OIL CONSERVATION DIVISION
1220 South St. Francis Dr.
Santa Fe, NM 87505

WELL API NO. 30-025-22678
5. Indicate Type of Lease STATE ☒ FEE ☐
6. State Oil & Gas Lease No.
7. Lease Name or Unit Agreement Name Sue
8. Well Number 1
9. OGRID Number 247692
10. Pool name or Wildcat Bagley Permo Penn North

SUNDRY NOTICES AND REPORTS ON WELLS (DO NOT USE THIS FORM FOR PROPOSALS TO DRILL OR TO DEEPEN OR PLUG BACK TO A DIFFERENT RESERVOIR. USE "APPLICATION FOR PERMIT" (FORM C-101) FOR SUCH PROPOSALS.)	
1. Type of Well: Oil Well ☒ Gas Well ☐ Other	
2. Name of Operator Jay Management Company, LLC	
3. Address of Operator 2401 Fountain View, Suite 420 Houston, TX 77057	
4. Well Location Unit Letter M : 660 feet from the South line and 660 feet from the West line Section 29 Township 11 S Range 33 E NMPM County Lea	
11. Elevation (Show whether DR, RKB, RT, GR, etc.) 4331 KB

**CONDITIONS OF APPROVAL
FOR PLUGGING AND ABANDONMENT
OCD - Southern District**

Propose WB Diagram

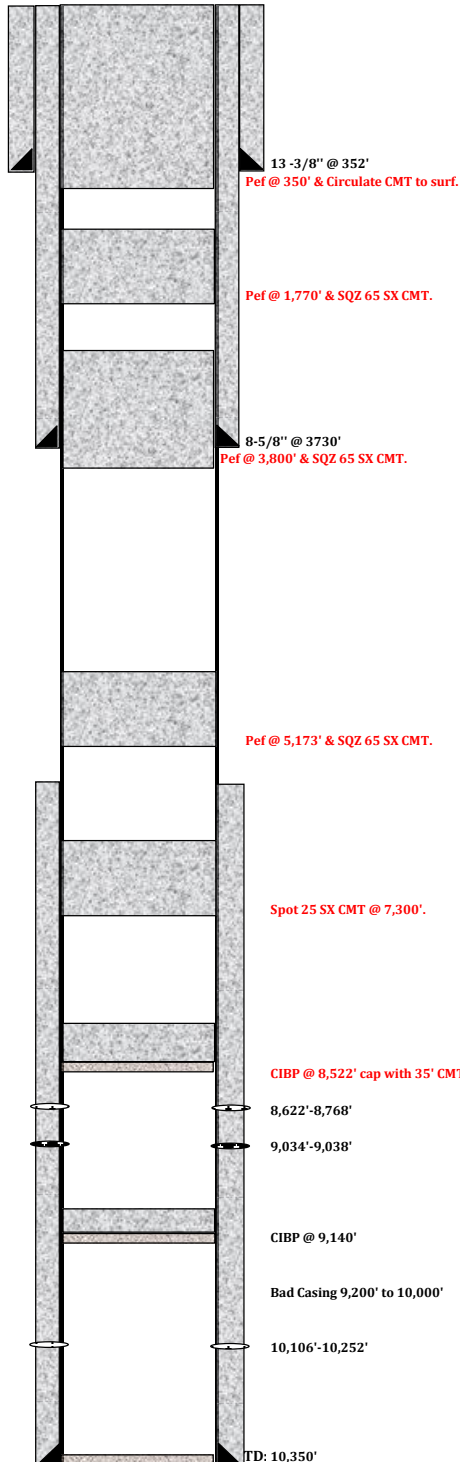
Bad Casing from 9,200' to 10,000
Propose P&A
CIBP @ 8,522' cap with 35' CMT.
Spot 25 SX CMT @ 7,300'.
Pef @ 5,173' & SQZ 65 SX CMT.
Pef @ 3,800' & SQZ 65 SX CMT.
Pef @ 1,770' & SQZ 65 SX CMT.
Pef @ 350' & Circulate CMT to surf.

11. Class 'C' cement will be used above 7500 feet.
12. Class 'H' cement will be used below 7500 feet.
13. A cement plug is required to be set 50' above and 50' below, casing stubs, DV tools, attempted casing cut offs, cement tops outside casing, salt sections and anywhere the casing is perforated, these plugs require a 4 hour WOC and then will be tagged

17. A CIBP is to be set within 100' of production perforations, capped with 100' of cement, WOC 4 hours and tag.
18. A CIBP with 35' of cement may be used in lieu of the 100' plug if set with a bailer. This plug will be placed within 100' of the top perforation, (WOC 4 hrs and tag).
